TO: Lynnfield Planning Board
FROM: Cheri Ruane, RLA
DATE: April 9, 2008
SUBJECT: Lynnfield Meadow Walk 40R Landscape Peer Review
FINAL REPORT – DRAFT

Weston & Sampson was retained to perform Landscape Peer Review services for the Meadow Walk 40R development on behalf of the Lynnfield Planning Board. Per the scope of work outlined in the Invitation for Bid we have reviewed the project submission materials, met with the applicant for two “working sessions”, and attended two public hearings (3/13 and 3/26). The results of our comprehensive review have been summarized in this report.

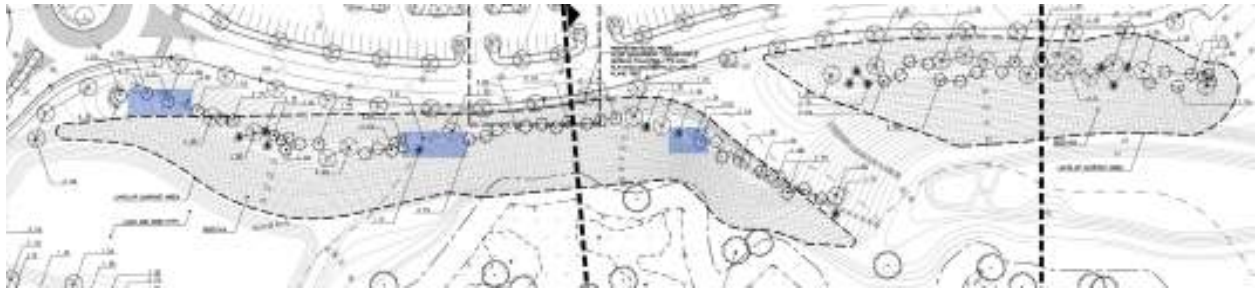
Quercus macrocarpa is identified on the bioretention swale planting plant list. We did a cursory search of three local nurseries and were unable to find that species.
